RE: Subsidence of a portion of the once Proposed Lawrence Reservoir Site, Skyline Mine, Canyon Fuel Company L.L.C. Skyline Mine, C/007/005

Re: **AMENDED** Approval of the Minor Modification to the Resource Recovery and Protection Plan (R2P2), and revised conditions of approval to extract the 12 Left "A" panel in Skyline Mine #3 Level 2, in the old "Lawrence Reservoir site", under Burnout Creek.

Map

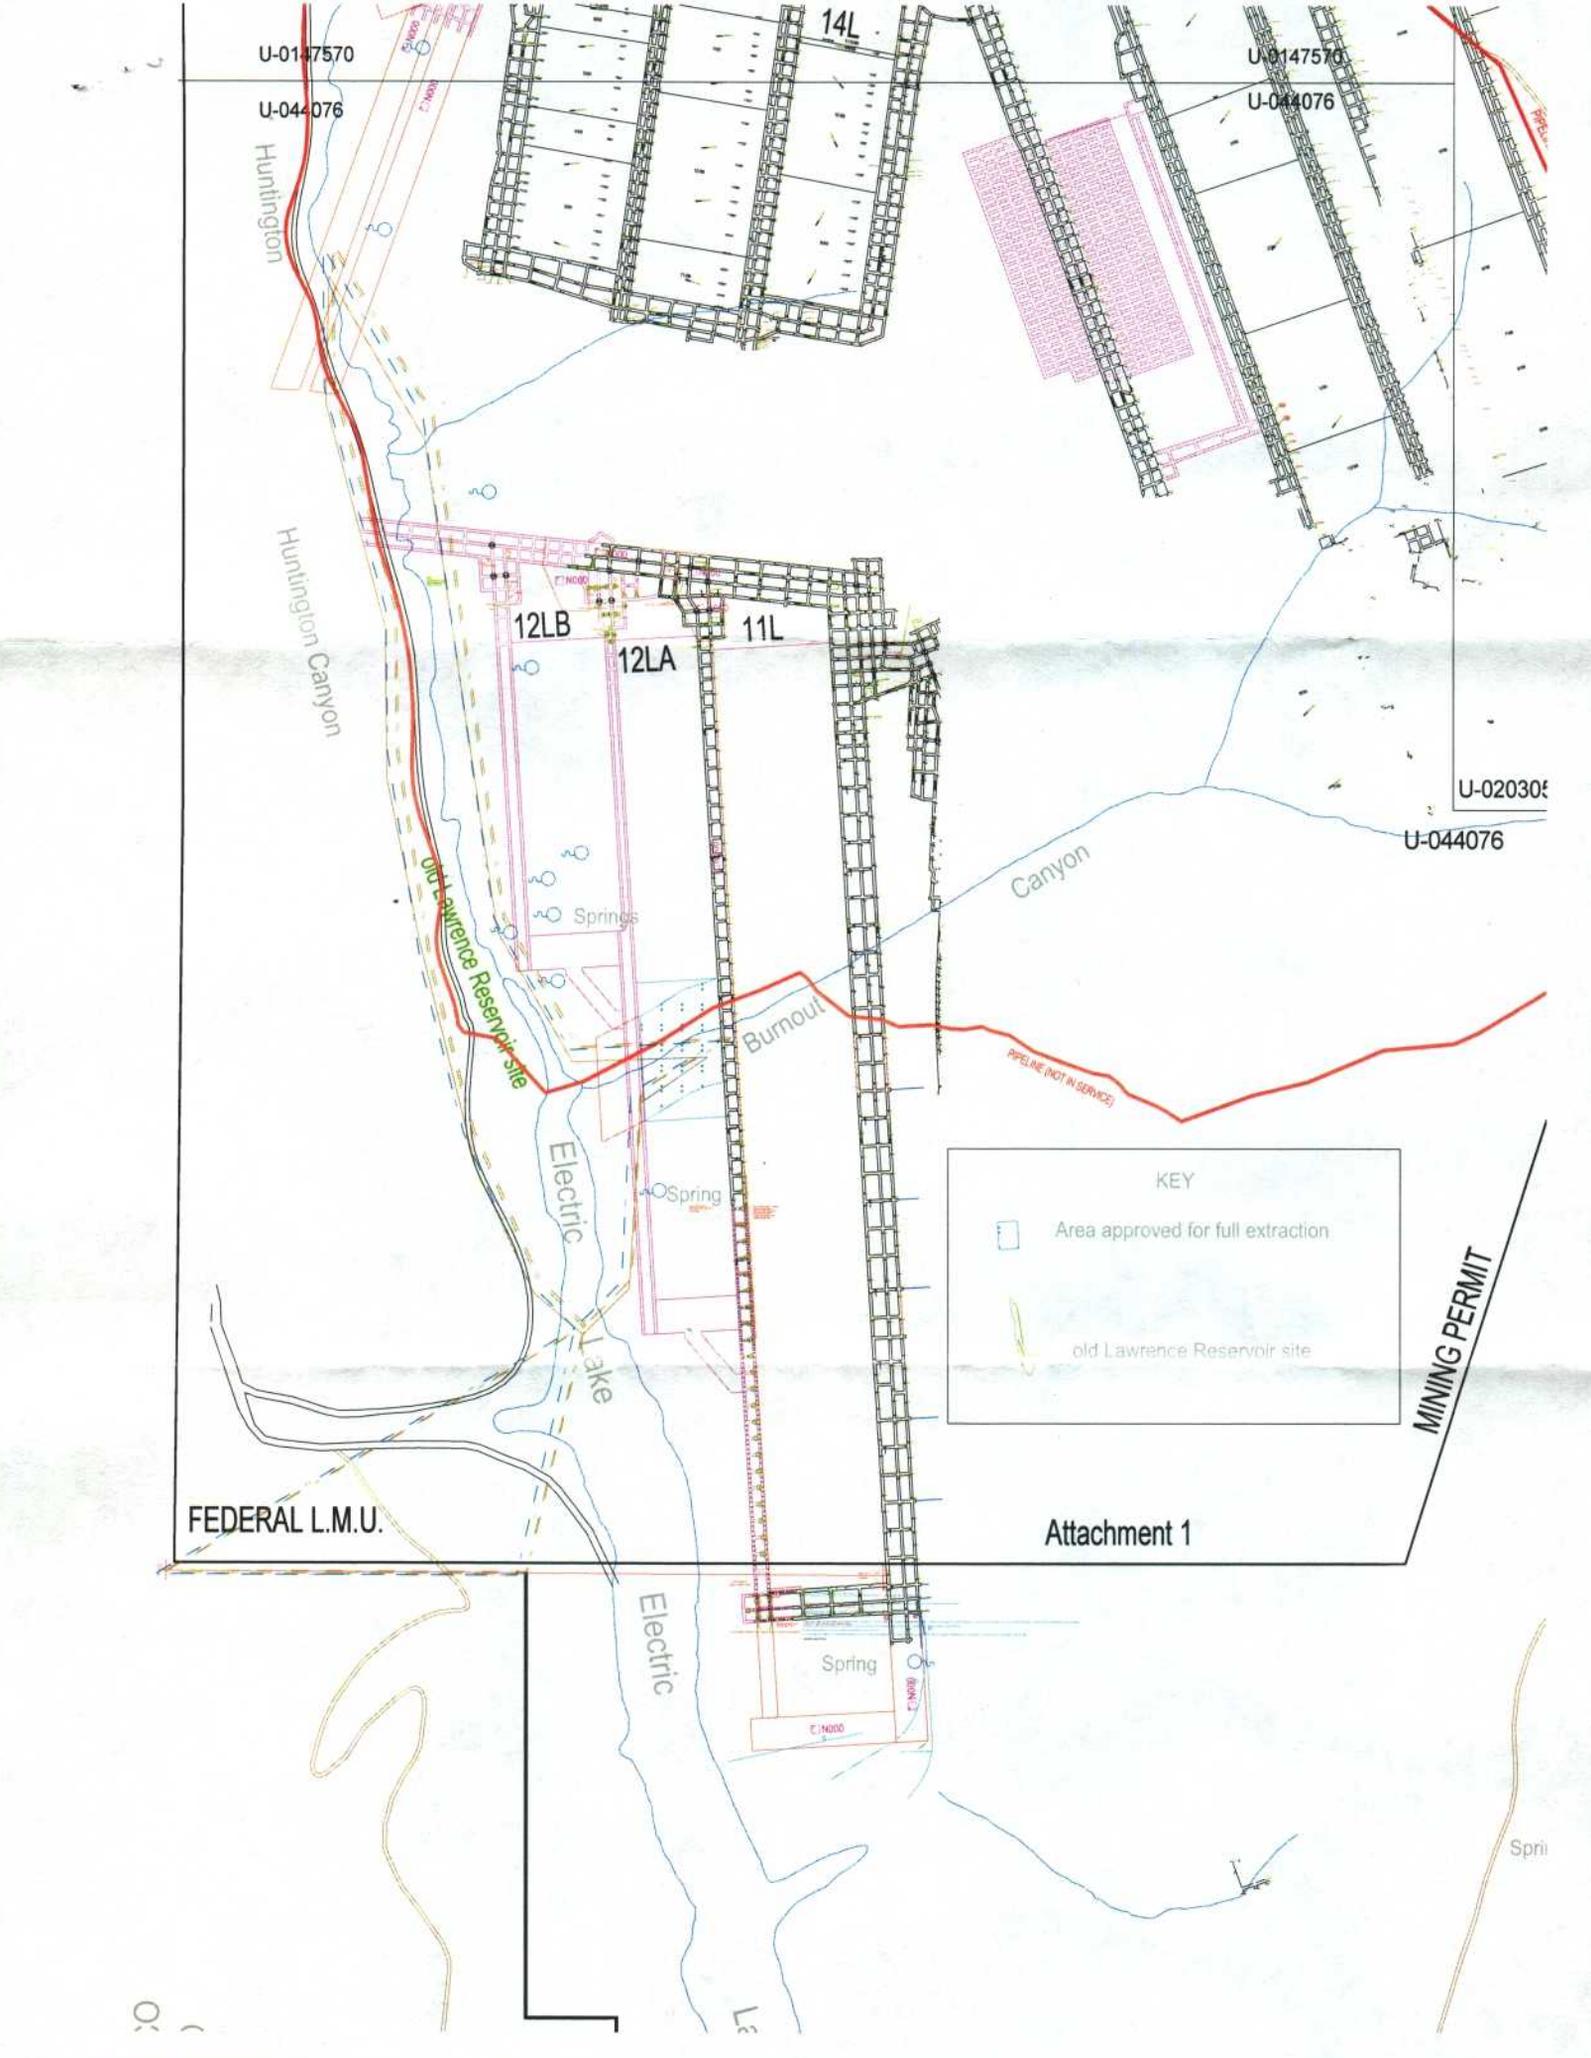
Approval: BLM approves the longwall recovery in the 12 Left "A" Panel in the old "Lawrence Reservoir site" under Burnout Creek as per the attached map.

1. BLM will require that a 22-degree angle of draw plus 25 feet be maintained from the edge of the longwall panel to the high water level of Electric Lake. No full extraction is authorized in this area.
2. Canyon Fuel Company will notify the BLM 24 hours prior to longwall mining in the area of the angle of draw under Burnout Creek in the 12 Left "B" Panel. Once extraction has commenced under the Burnout Creek area, mining will continue without cessation (extraction cannot be halted for more than 72 hrs.) until the entire area (100 feet in by the

stream crossing until the mid face of the longwall is under the stream. This is approximately 240 feet.) has been traversed unless safety or unforeseen equipment problems arise. Skyline Mine will monitor the shield pressures in this area on a daily basis (including idle days) and submit the results to the BLM not more than 30 days after mining in this area.

3. BLM will require immediate notification of any mine induced seismic events that are larger than magnitude 3.0 as measured on the Richter scale.
4. Canyon Fuel Company will monitor the surface of the Burnout Creek area and immediately notify the BLM of any observed surface impacts.
5. Canyon Fuel Company will lower the shields starting at the head gate to 10 feet for 1/3rd of the length of the longwall and grade out to the center of the panel to full longwall height in order to reduce the subsidence in the area next to the virgin coal abutment pillar under the stream.
